Material errors in the PEIR for Calderdale Energy Park

I am writing formally to notify you of material geospatial errors in the PEIR layout presented for Statutory Consultation. The errors are so elementary and fundamental that they indicate extensive delinquency in the whole PEIR, which should be withdrawn, subjected to proper checking throughout, corrected, and published again as version 2. Since the present PEIR contains a great deal of evidence about systemic failures by CWF Ltd and their consultants Logika, it must be retained pending a possible judicial review of the planning process for CEP. We suggest that the loose-leaf binders in use at the public exhibitions would be a reliable evidential archive for legal purposes.

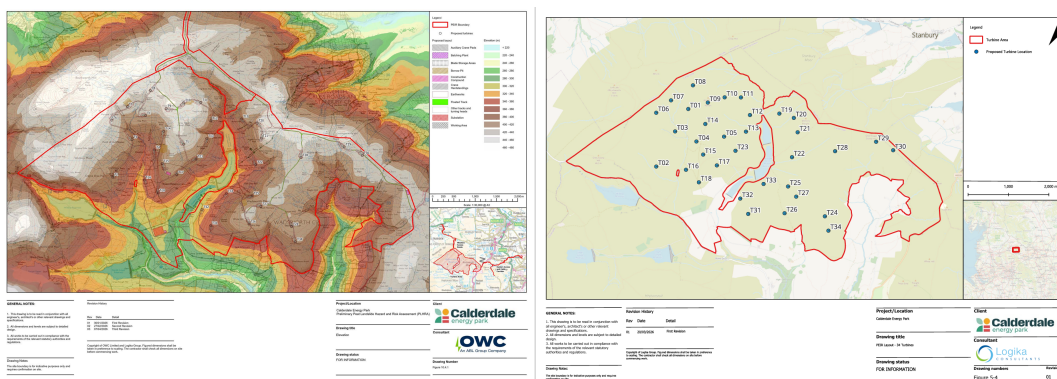
The co-ordinates of the turbine locations in three dimensions are given to millimetric accuracy because the eastings and foundation heights are given to 3 decimal places. It is these co-ordinates that the Statutory Consultees use for their work on the PEIR.

Variation between geospatial Table 4-1 and the geospatial map 10.4.1. The yellow dots are the positions of the turbines as given in Table 4-1. The black circles are the mapped positions. The maximum error is 220 metres at T28.

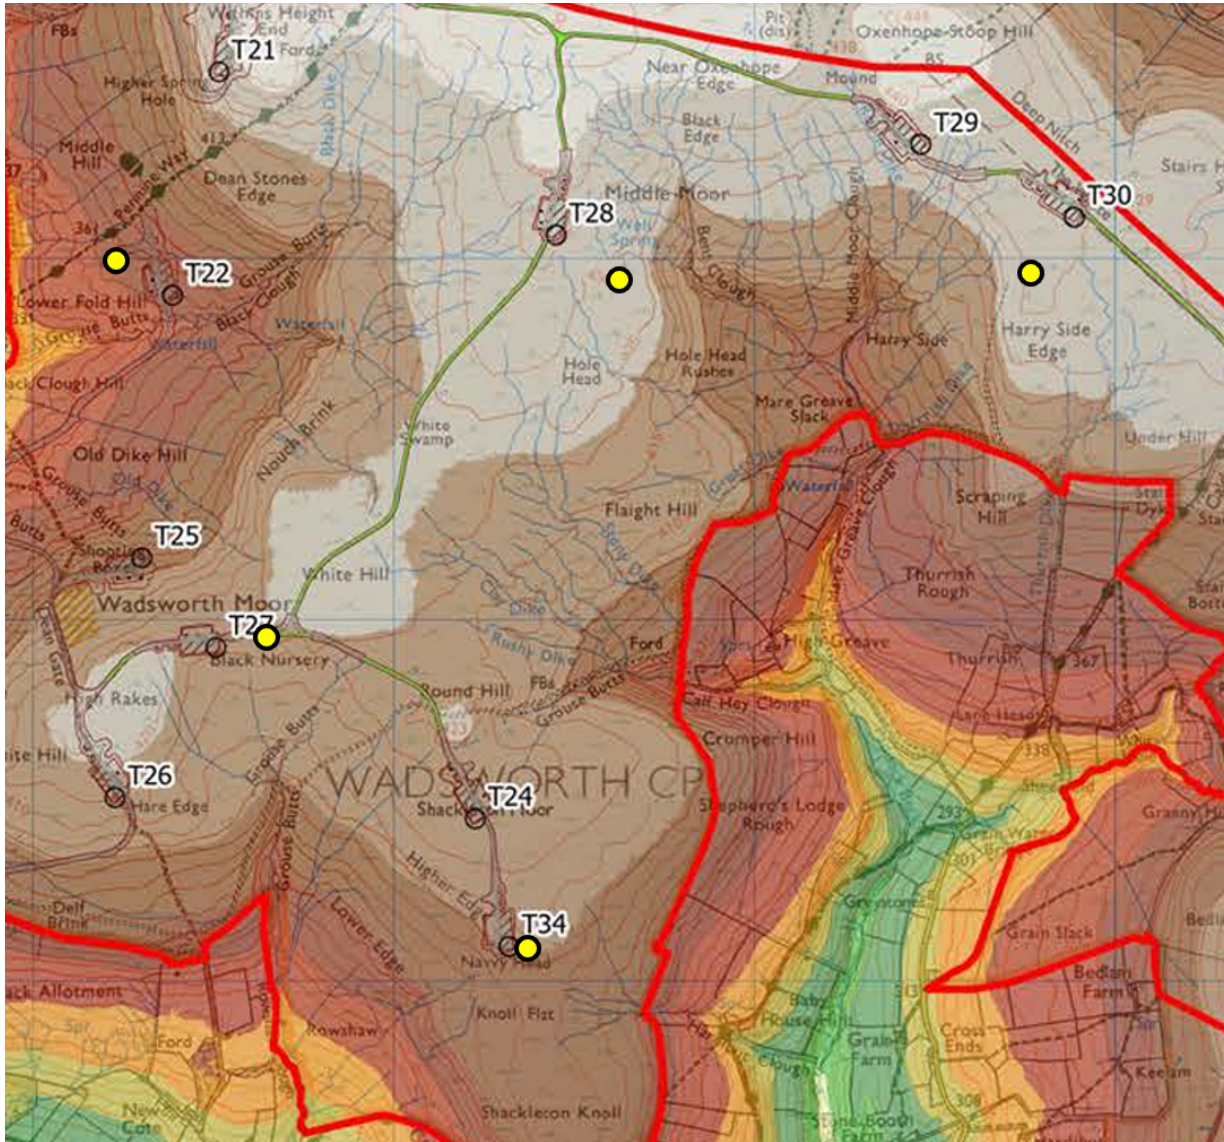
These, and many other maps, do not correctly represent the geospatial data given in table 4-1. The largest discrepancy between the maps and the geospatial data is over 220 metres at T28.

The errors are considerable in the turbine area east of the Walshaw Dean Reservoirs. Our map below plots the geospatial positions given in Table 4-1 using a yellow dot in a black boundary.

The error at T22 impacts analysis of the proximity of T22 to the Pennine Way. The distance of the correct position (yellow dot) from the Pennine Way is 71 metres, which means the blades of the candidate turbine (Vestas 7.2/160) used for modelling noise in the SR, for example would oversail the national trail. A safe setback would be tip height plus 10% which is 220 m.

The error at T30 impacts calculations of the visual dominance of T30 over the King's Bradford Pennine Gateway NNR at Penistone. It is not known if the wire diagrams provided in the PEIR use the correct coordinates.

Peat slide analysis of the ground under the track to T22 cannot be checked because of the 175 metre error in the position of T22 in the maps of Factor of Safety in Appendix 10-4.

Given the vast weight of maps listed below, it would be easier for CWF Ltd to bring Table 4-1 into line with the maps rather than vice versa. The Statutory Consultees cannot be expected to double guess this matter. The statement of the PEIR is that the Table 4-1 is primary, and statutory consultees must use the table to do their analyses or they are reduced to estimating turbine locations from maps that are wrong.
